SCOTTSDALE

Unified School District

SCHEMATIC DESIGN UPDATE

November 23, 2020

COMMITTEE FEEDBACK

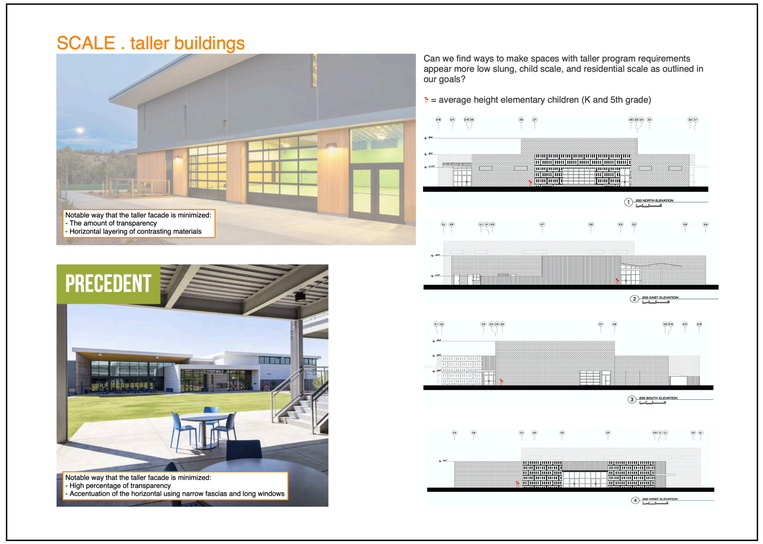
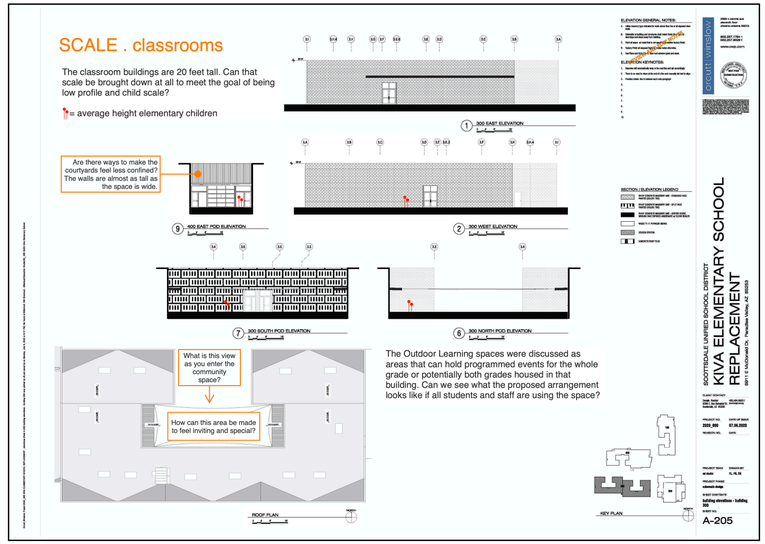
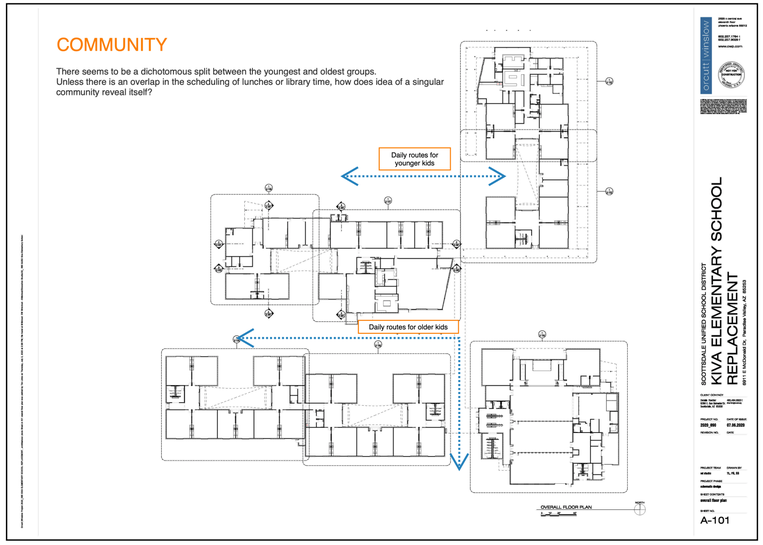
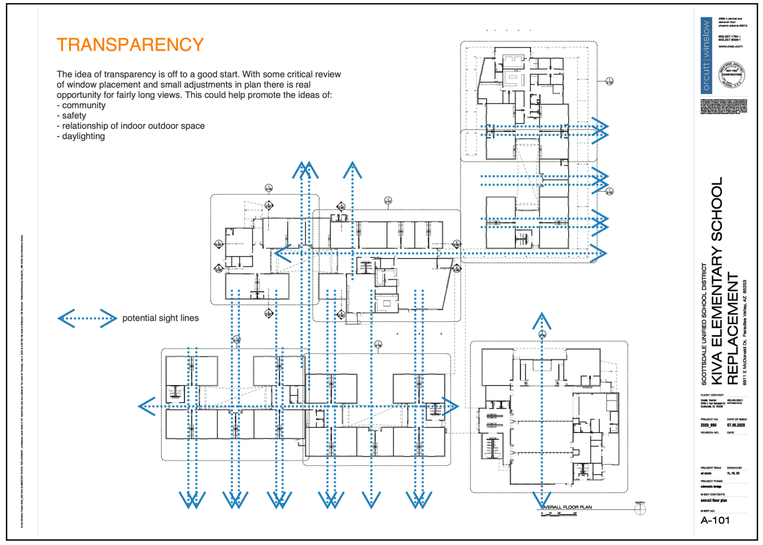
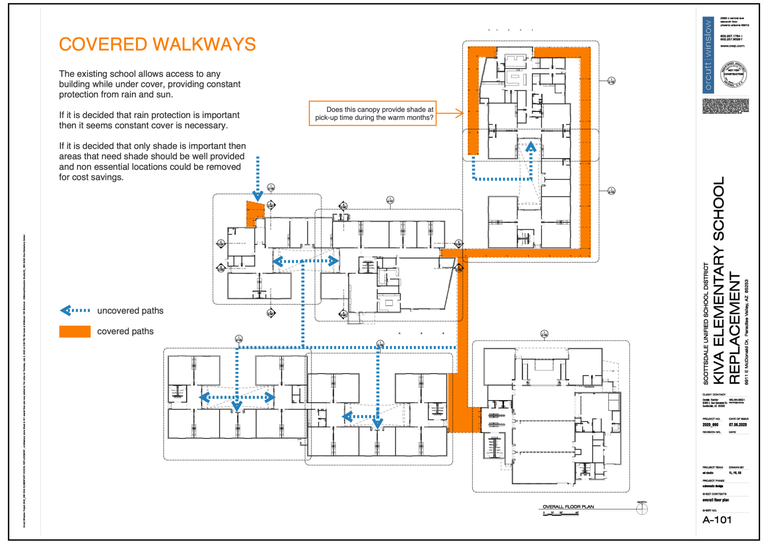
- The site design needs to **provide ample free green space within the playgrounds for Kindergarten and 1st grade**. This concern was brought up in previous site arrangements in which building 400 took up quite a bit of the available space at that location. Since modifying the programming of this building, the design will allow for an arrangement that will positively affect the amount of green space for these purposes.

- **Restroom access for Kindergarten and 1st grade while using their fields/playgrounds** needs to be provided to allow for good line of sight.
- **Canopy heights will be adjusted down as low as possible, to better provide usable shade and reduce the overall impact of the scale of the buildings.** Shade studies will be performed to confirm or adjust placement to maximize their use during drop-off and pick-up. Canopy coverage during rain events was discussed. The design team will look at possible ways to maximize the amount of campus that affords this coverage.

- **Strategies of reducing the height of buildings**, such as lowering of parapet heights and providing separate screening for roof top mechanical units will be explored.

- **Current utilization of the Vocal, Band & Strings program will be confirmed.** A design that reflects current usage and future projected usage will be explored. Providing ease of future expansion will be incorporated to the greatest extent possible.

- A **full traffic impact analysis will be performed** to identify all available strategies to limit traffic disturbance in the neighborhood while providing a safe arrival and departure sequence for all pedestrians and vehicles on campus.
